We would like to thank both reviewers for their thorough reviews of our manuscript. Here, we briefly summarize a few of the more substantial revisions we have made to address reviewer comments:

Reviewer 1

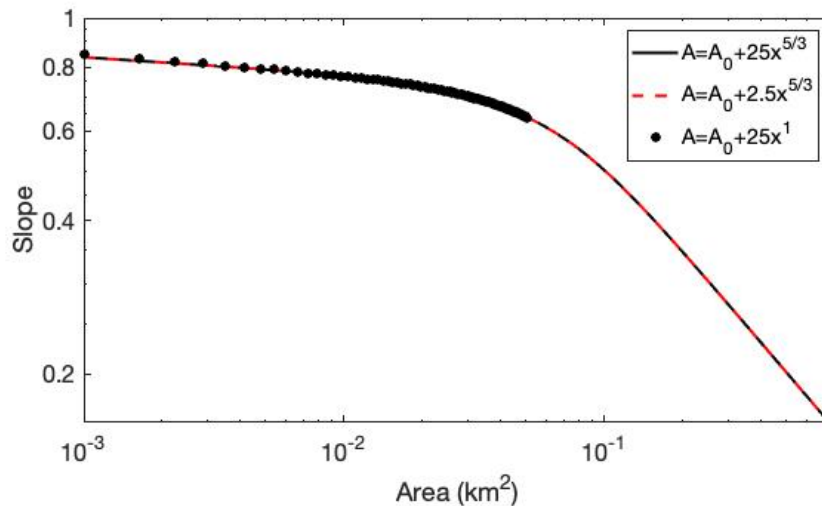
Line 114: I would suggest to provide a number to this equation, and to discuss more at length the choice of the parameters, and in the discussion the implications of this choice.

R: The implications are minor for this study because there is nothing that is parameterized within the debris flow models as a function of channel length. The relationship between area and downstream distance mostly affects the length of the model domain. See figure below for examples of a modeled channel profile at steady state using different exponents and coefficients in this relationship.
